Re: Work Plan Addendum
76 Service Station No. 4186
1771 First Street
Livermore, California
Delta Project No. C104186181

On behalf of ConocoPhillips Company (COP), Delta Consultants, Inc. (Delta) has prepared this *Work Plan Addendum* proposing the installation of four middle water bearing zone and three lower water bearing zone groundwater monitoring wells. In addition, Delta proposes the abandonment of eight ozone injection wells and the installation of four additional ozone injection wells, two in the upper water bearing zone and two in the middle water bearing zone to address dissolved phase petroleum hydrocarbons in the groundwater at the above-referenced site.

FIGURE 2
SITE PLAN

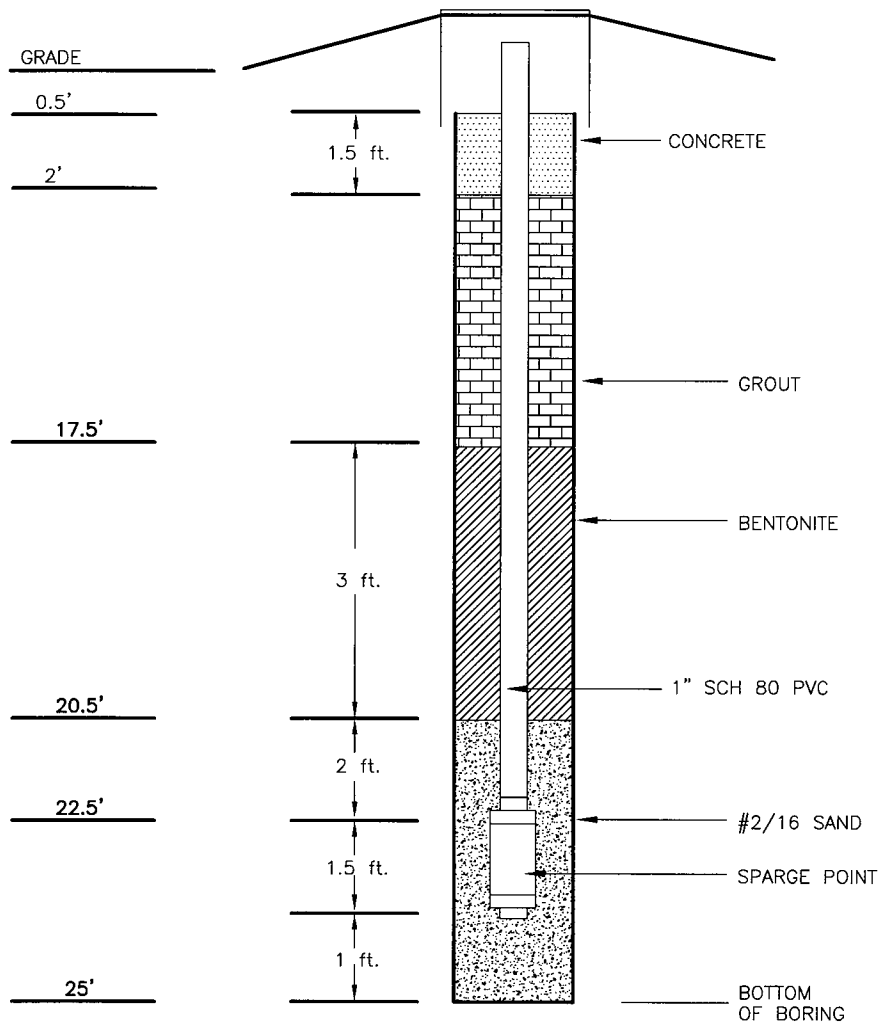
To attempt to remediate the dissolved phase petroleum hydrocarbons in the groundwater at the site and limit the off-site migration of dissolved phase petroleum hydrocarbons in the groundwater, Delta proposes the installation of three ozone injection wells at the locations shown on Figure 2, in addition to the installation of the seven ozone injection wells proposed in the previous work plan. As discussed above, these three wells as well as one of the wells discussed in the previous work plan will replace ozone injection wells SP-5, SP-5S, SP-8, and SP-8S with screen intervals corresponding with the upper and middle water bearing zones.

Delta proposes the installation of four monitoring wells to monitor the dissolved phase petroleum hydrocarbons in the groundwater in the middle water bearing zone. The proposed monitoring well locations are shown on Figure 2.

Delta proposes the installation of three monitoring wells to monitor the dissolved phase petroleum hydrocarbons in the groundwater in the lower water bearing zone. The proposed monitoring well locations are shown on Figure 2.

FIGURE 3
UPPER ZONE OZONE INJECTION
WELL CONSTRUCTION DIAGRAM
76 SERVICE STATION 4186
1771 FIRST STREET
LIVERMORE, CALIFORNIA

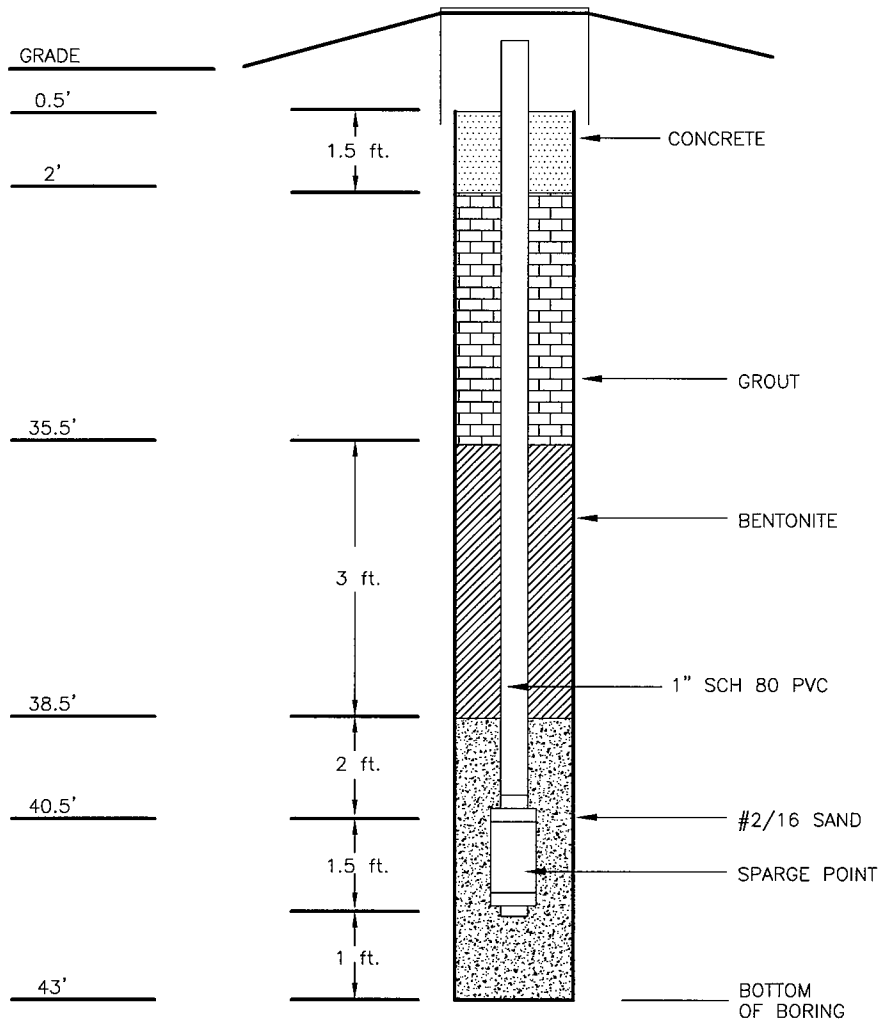
from the total depth of the well boring to 2 feet above the top of the sparge point, sealed with bentonite chips saturated in place and then capped to the ground surface with cement grout and completed with traffic-rated vault boxes. The sparge point depth will be based on the subsurface lithology encountered in the borings. A diagram detailing the proposed upper water bearing zone injection well construction is included as Figure 3.

Delta anticipates that the proposed upper water bearing zone injection wells will be installed to a depth of approximately 25 feet bgs, with the sparge point placed from approximately 24 to 22.5 feet bgs.

FIGURE 4
 MIDDLE ZONE OZONE INJECTION
 WELL CONSTRUCTION DIAGRAM
 76 SERVICE STATION 4186
 1771 FIRST STREET
 LIVERMORE, CALIFORNIA

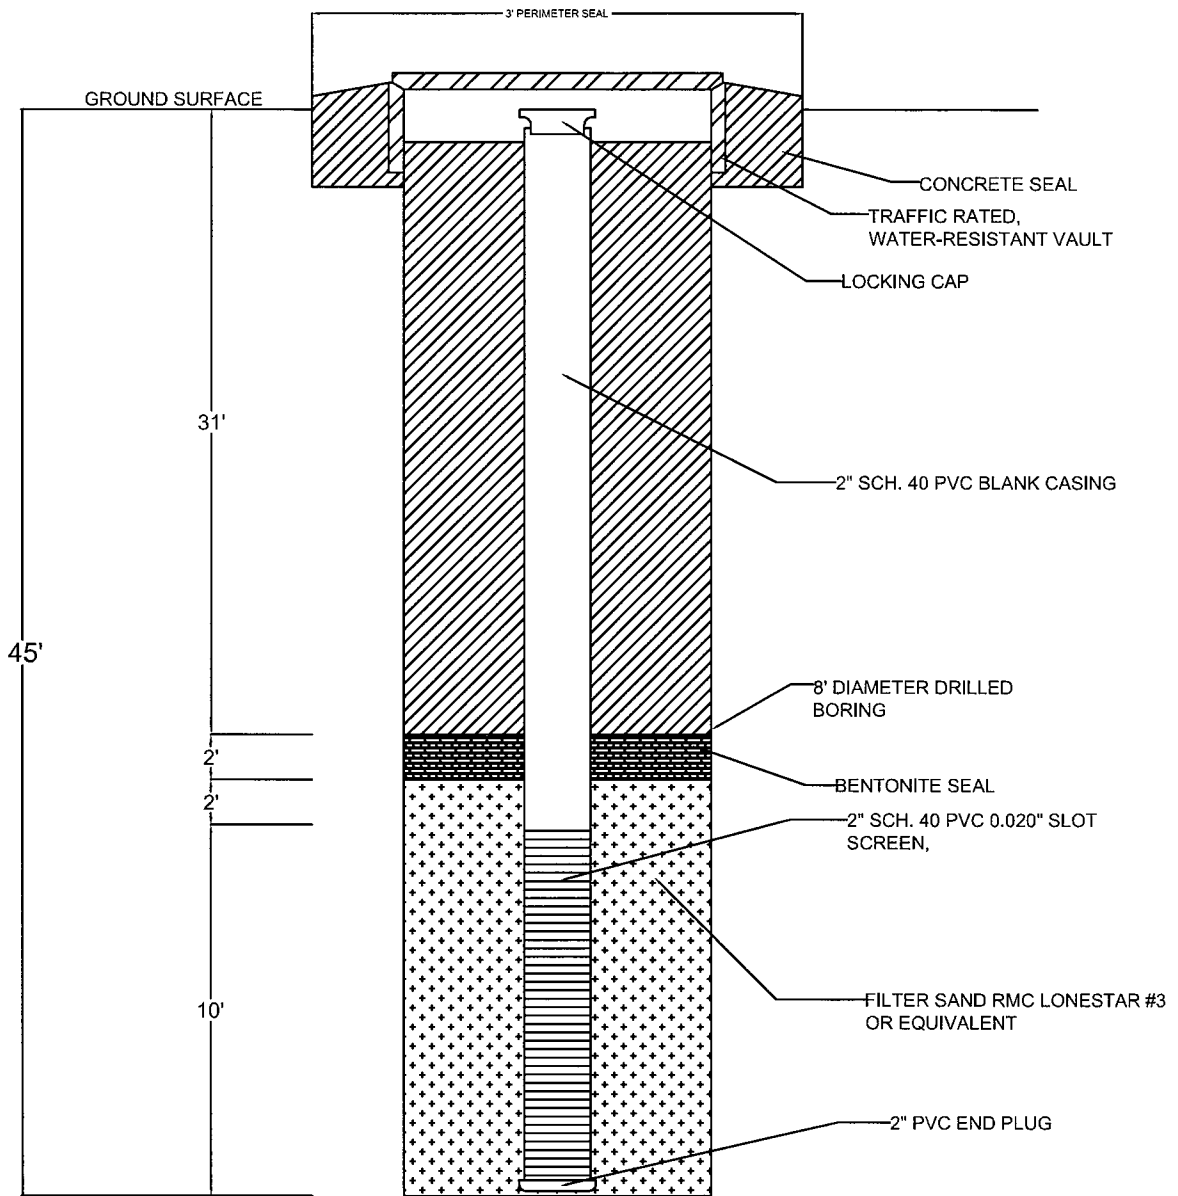
The well borings will be advanced with truck-mounted 8-inch hollow-stem auger equipment. The injection wells will be constructed with 1.5-inch diameter by 18-inch-long sparge points attached to 1-inch Schedule 80 polyvinyl chloride (PVC) casing to near surface grade capped with a wellhead connection. A sand filter pack will extend from the total depth of the well boring to 2 feet above the top of the sparge point, sealed with bentonite chips saturated in place and then capped to the ground surface with cement grout and completed with traffic-rated vault boxes. The sparge point depth will be based on the subsurface lithology encountered in the borings. A diagram detailing the proposed middle water bearing zone injection well construction is included as Figure 4.

Delta anticipates that the proposed middle water bearing zone injection wells will be installed to a depth of approximately 43 feet bgs, with the sparge point placed from approximately 42 to 40.5 feet bgs.

FIGURE 5
PROPOSED MIDDLE ZONE MONITORING
WELL CONSTRUCTION DETAIL
76 SERVICE STATION NO. 4186
1771 FIRST STREET
LIVERMORE, CALIFORNIA

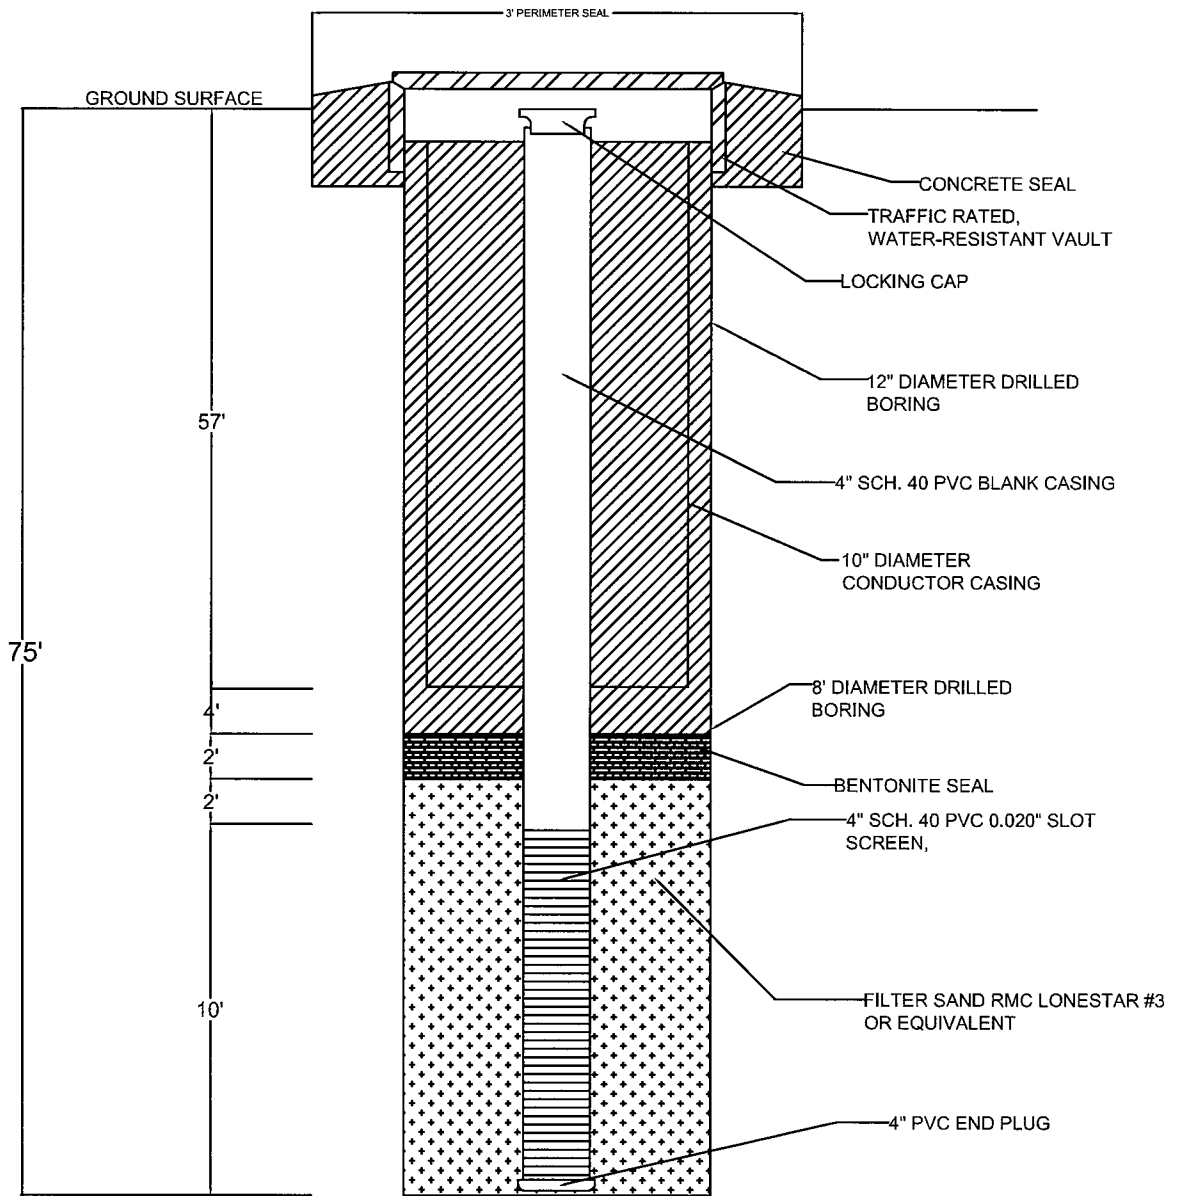
The borings will be converted to a groundwater monitoring well by installing a 2-inch diameter schedule 40 PVC well casing with a screened interval based on the lithology encountered during well installation. The screen interval is anticipated to be between 35 and 45 feet bgs, to correspond with the anticipated depth of the middle water bearing zone. The perforation size in the screen interval will be 0.020-inch. A sand pack of RMC Lonestar Sand #3 or equivalent will be installed into the annular space and extend approximately two (2) feet above the top of the screen interval.

A two (2) foot thick bentonite seal will be placed on top of the sand pack. The well will be surged prior to the placement of the bentonite seal to promote settling of the sand pack. The remainder of the annular space will be filled with neat cement and the well will be fitted with a locking cap and encased in a traffic-rated protective vault placed at existing ground level. A diagram detailing the proposed middle water bearing zone monitoring well construction is included as Figure 5.
